ENVIRONMENTAL REVIEW TEAM REPORT
ON
WINDHAM HILL
ASHFORD AND WILLINGTON, CONNECTICUT
NOVEMBER, 1973

ENVIRONMENTAL REVIEW TEAM REPORT
ON
WINDHAM HILL
ASHFORD AND WILLINGTON, CONNECTICUT

The first phase of the Windham Hill development, with which this report is concerned, covers about 250 acres south of Route 44A and west of Howard Road. The topography map delineates the boundary of the first phase of development from the rest of the tract. Both an 18-hole golf course and mixed residential uses are proposed for the site. The general layout of the site, as proposed in the conceptual plan of development, is shown on the following page. It is anticipated that 135 single-family homes

WINDHAM HILL PRELIMINARY SCHEME OF DEVELOPMENT FOR FIRST PHASE

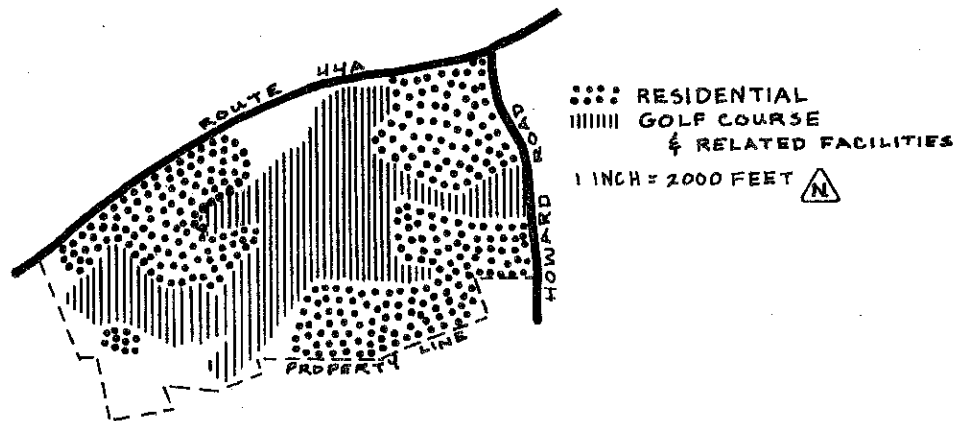
About thirty percent of the soils of the first phase fall under the inland wetlands classification as defined by P.A. 155. The golf course, as proposed, overlaps a substantial portion of this area. Besides the regulatory problems of P.A. 155, the extensive and elaborate drainage system and the fill that would be necessary to establish the golf course present serious questions as to the practicality and economic feasibility of the golf course.

In general, the concept of a combined golf course and residential development appears to be a good one. In this particular case, however, the intensity of development proposed for this site should be reevaluated with respect to its location within a water supply watershed and its relation to substantial wetland areas.

The generation of large amounts of traffic onto Howard Road should be discouraged due to its dangerous intersection with Route 44A. The plan as presently designed indicates that a large number of homes on the Ashford side of the development might be serviced by Howard Road. More convenient access to Route 44A would be preferable.

It does not appear practical or economically feasible to install a golf course as now proposed. A substantial portion of the golf course is located on poorly or very poorly drained soils that are designated as inland wetlands under P.A. 155. To develop a golf course that skirts a wetland could be both feasible and practical, but to develop a golf course through a wetland presents severe drainage and runoff problems that would be costly to correct. It should also be noted that fill over the wetland would also quickly become saturated unless the area is under-drained correctly.

SOIL MAP

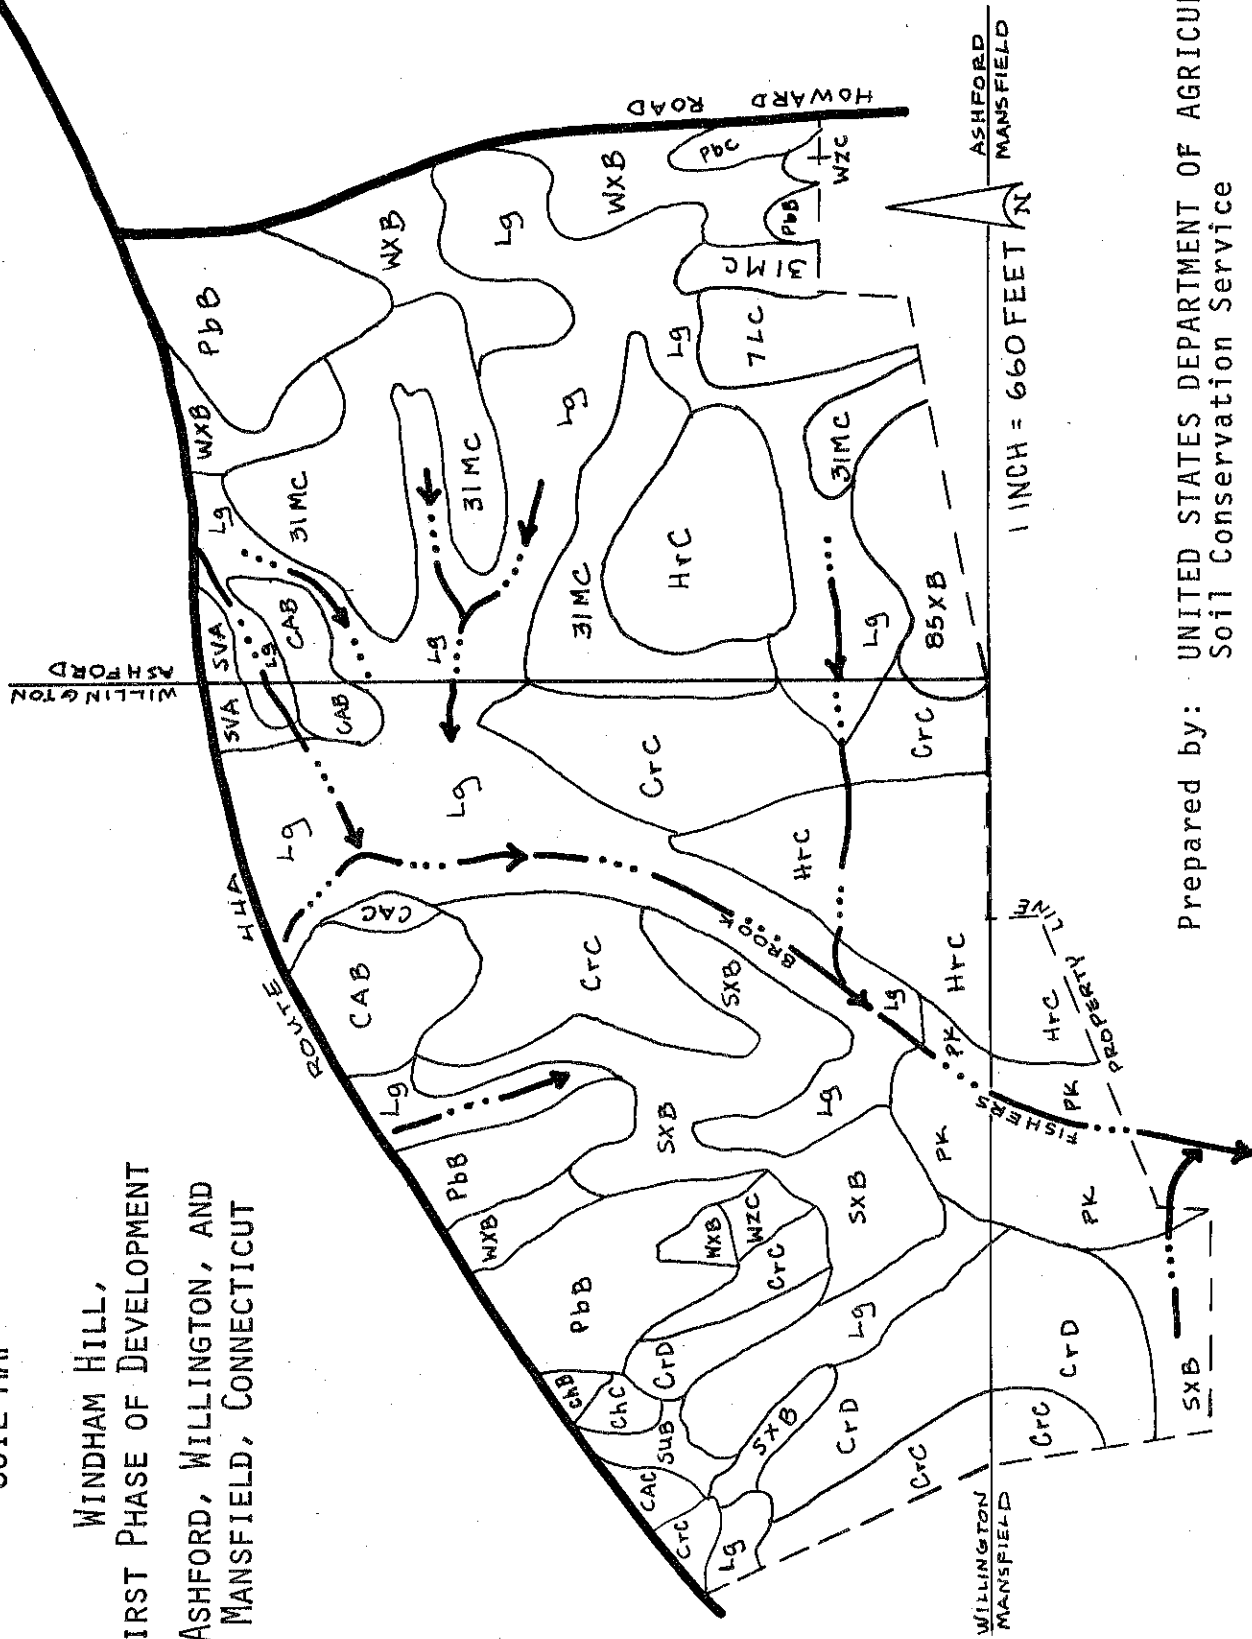
Due to the original scale at which the soils are mapped (1"=1,320'), the lines shown on the map should not be construed as precise boundaries, but rather as guidelines to the distribution of soil types on the property. For purposes of detailed site design, a new survey at a scale more suitable to site design (1"=100-200') would be desirable.
